**LEBANON PLANNING BOARD
JANUARY 10, 2022 - 6:30 PM
COUNCIL CHAMBERS, CITY HALL OR
REMOTE VIA VIRTUAL PLATFORM
LEBANONNH.GOV/LIVE**

**Mount Support Development, LLC
(applicant) and Sylvia D. Lahaye
Revocable Trust & Pat Lumber
Jack, Inc. (property owners), 402 &
392 Mount Support Road (Tax Map
24, Lots 9 & 10), zoned R-1
PB2021-33-SPR**

Staff Memorandum – PB2021-33-SPR – *con't from 12/13/21*

GRAVEL WETLAND

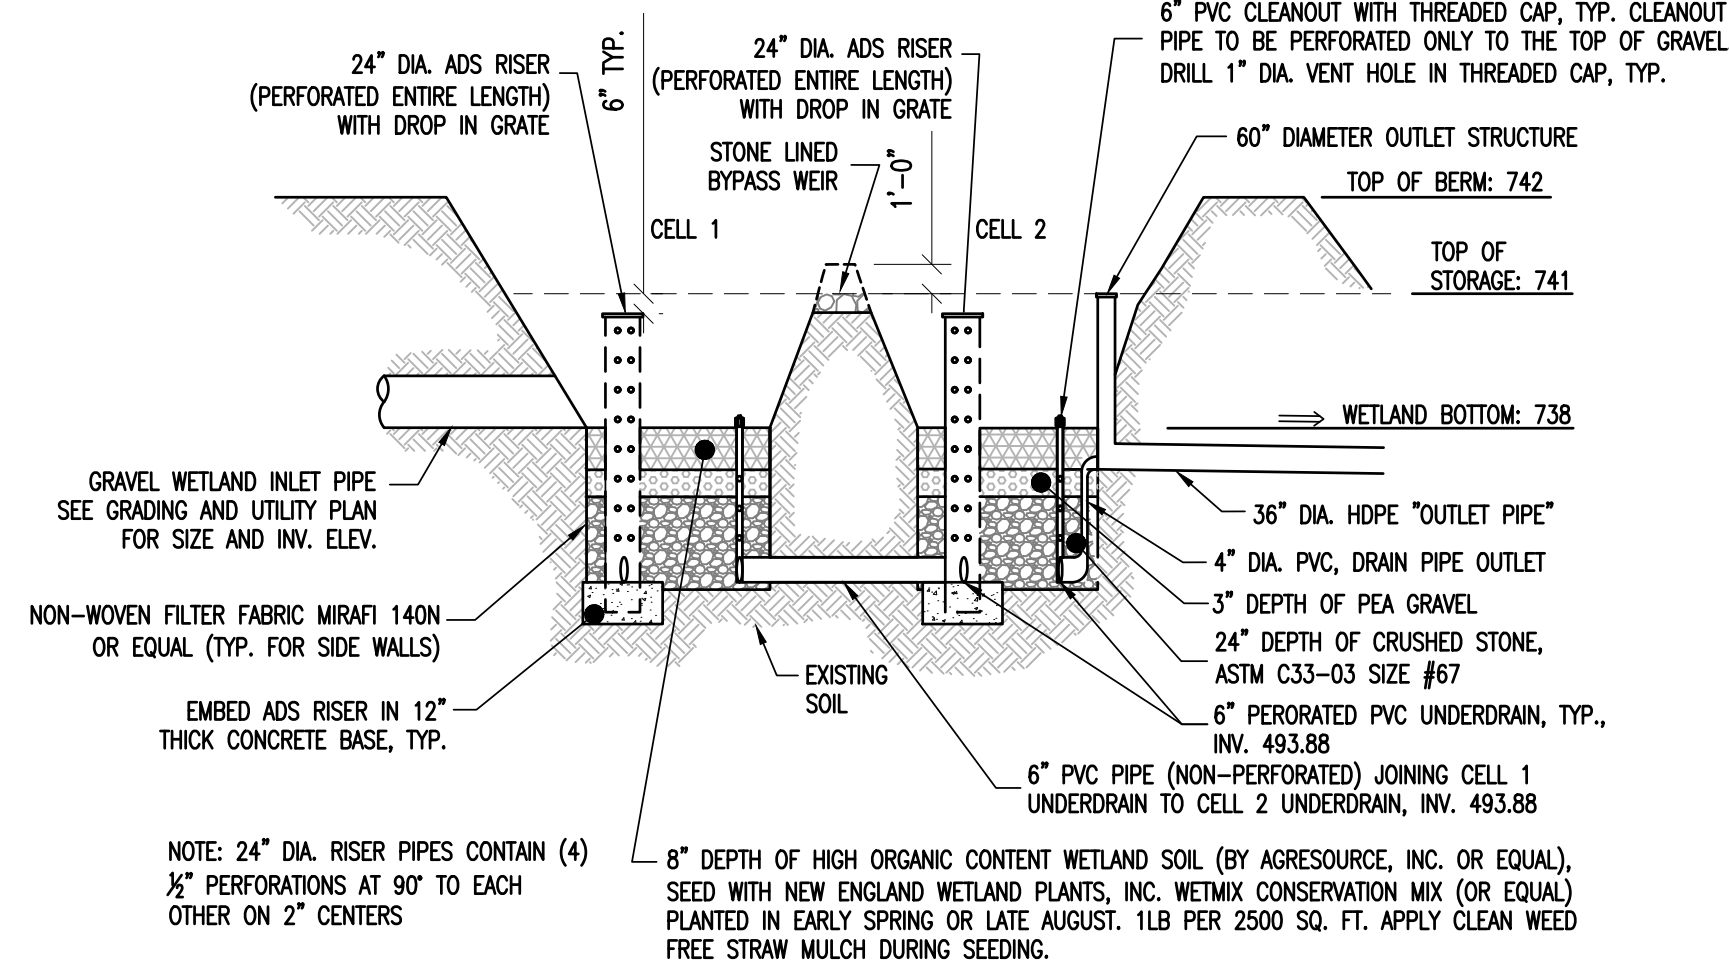
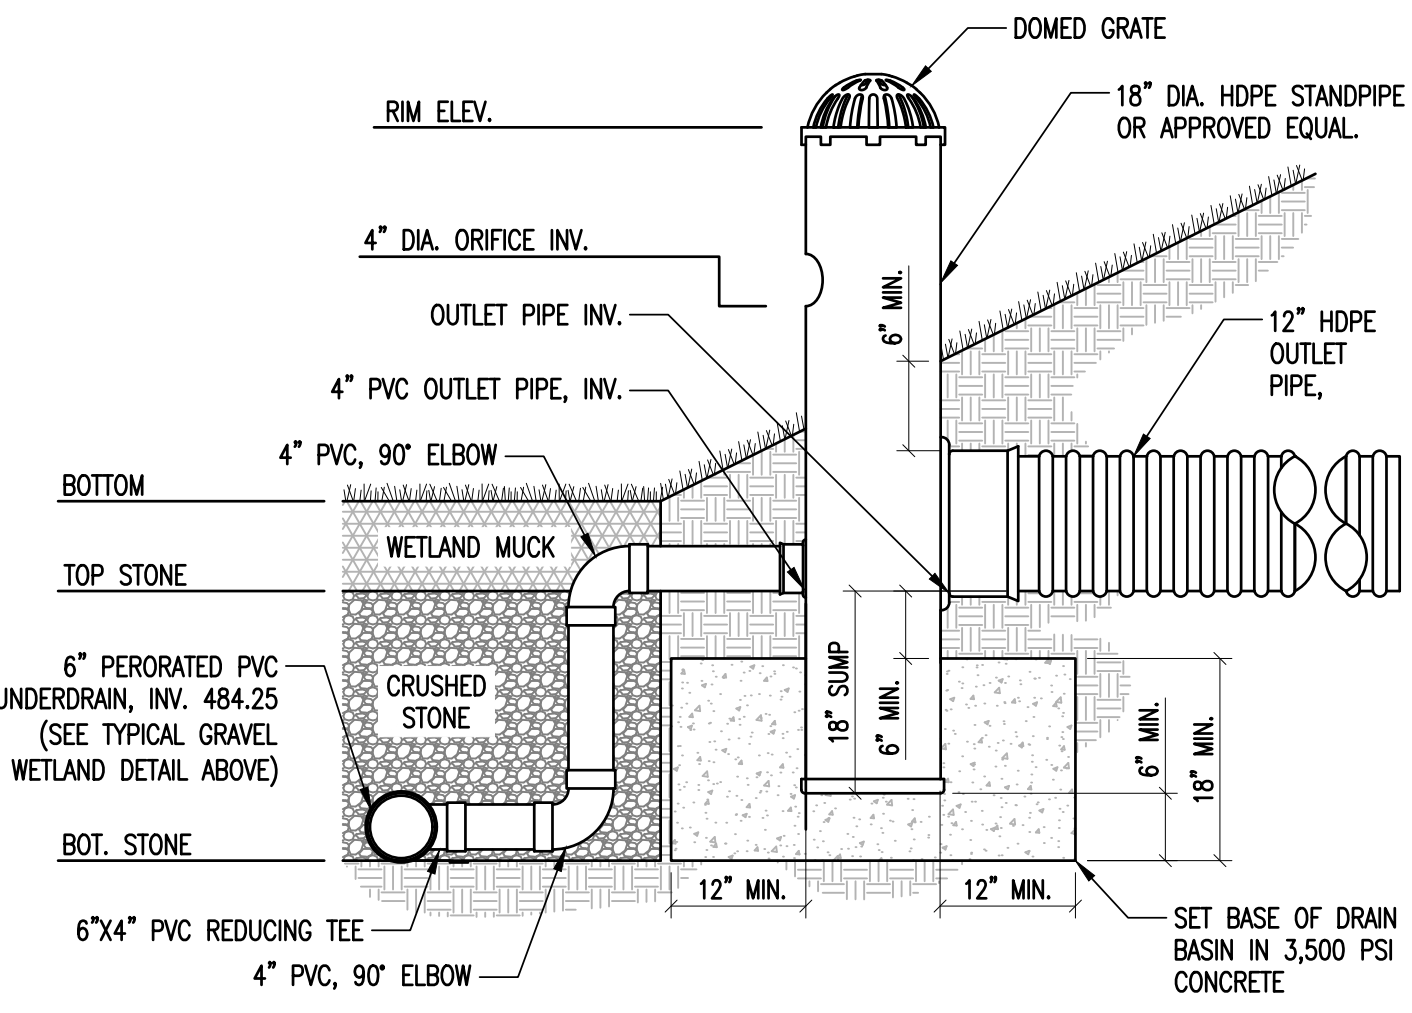
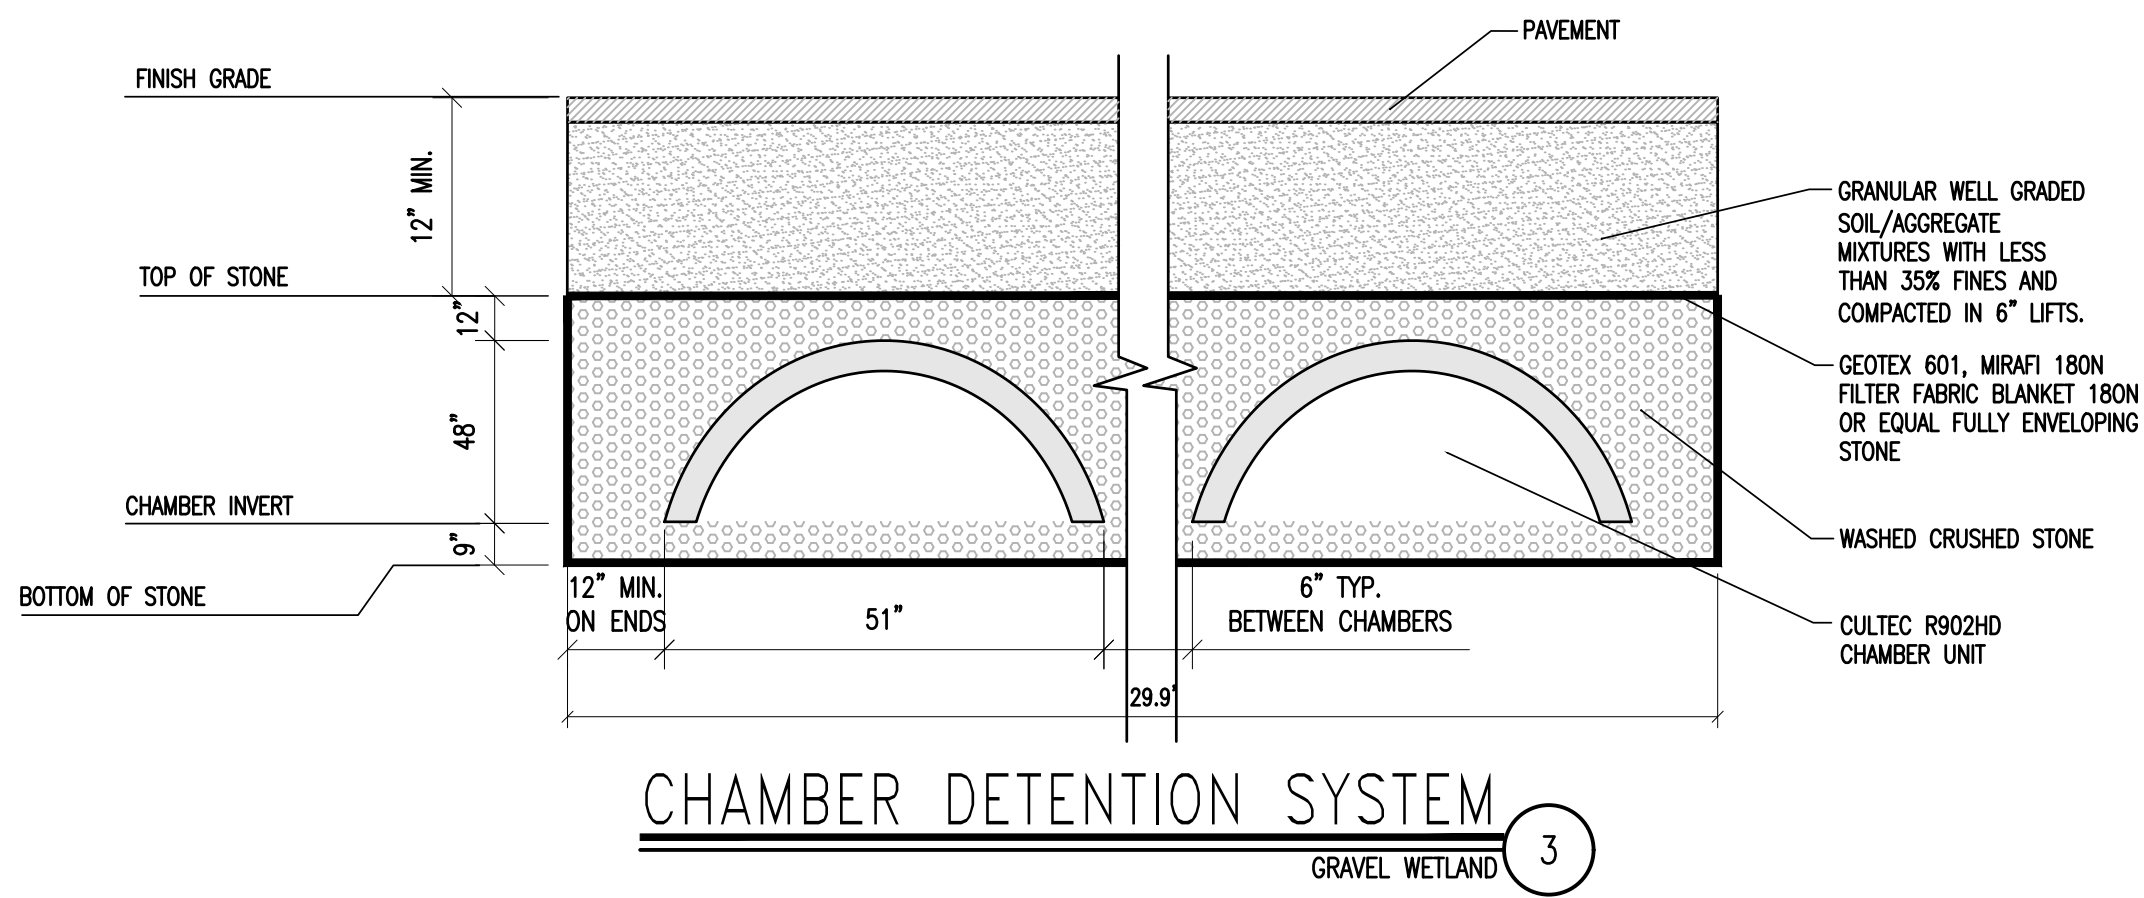
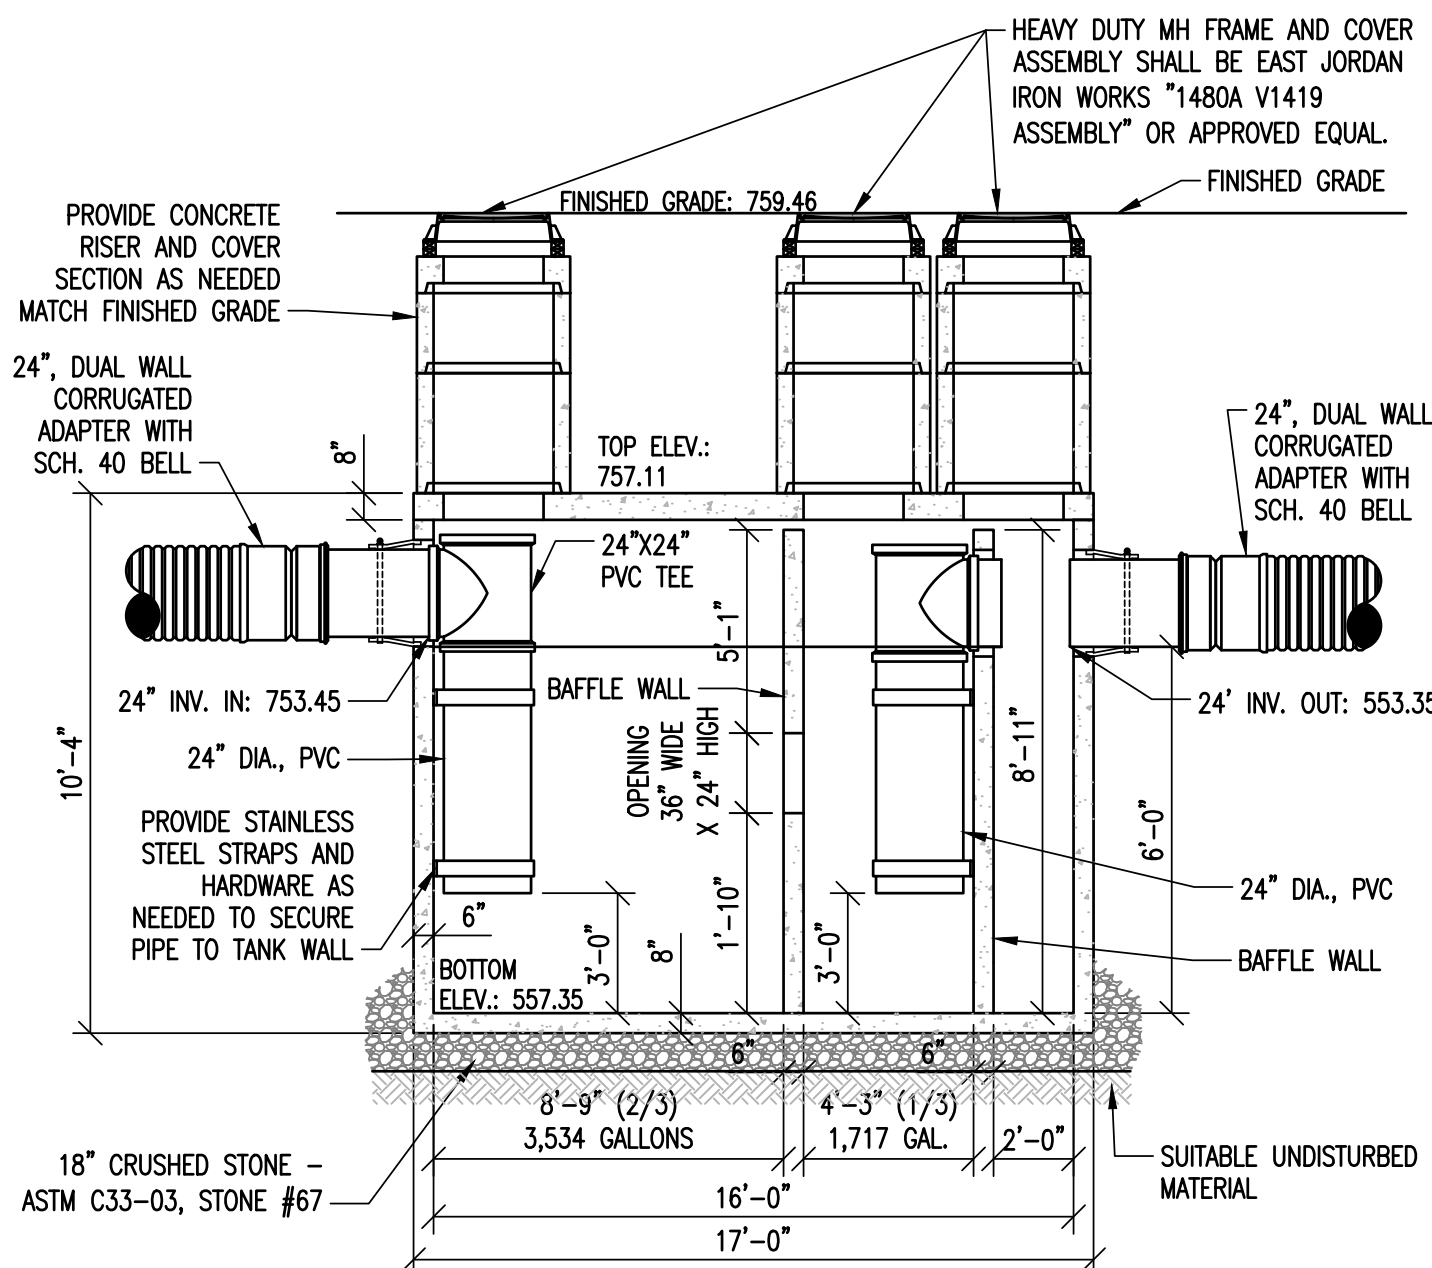
- An identical comment is offered with regard to the proposed gravel wetland to be constructed to the southeast of Building 4. When preparing the recommended detail, we suggest the design engineer reconcile design information for Outlet Structure D25 specified on Sheets C2.4 and C4.4 respectively. Although we acknowledge a typical detail of gravel wetland construction is provided on Sheet C4.4, we recommend this detail be edited to be site specific.

- Sheet C4.3 include a detail of a flat top drain manhole.
 - Sheet C4.4 includes a typical 5,000-gallon sediment forebay structure detail. We recommend the design engineer reconcile this detail with design data provided on Sheet C2.4 for consistency in terms of connecting pipe diameter. In addition, we recommend the detail be expanded to include specifications for structure bedding.

- Sheet C4.4 of the revised plan set includes a detail for the sediment forebay.
12. Based upon review and consideration of the applicant's Drainage Analysis we offer the following series of remarks:
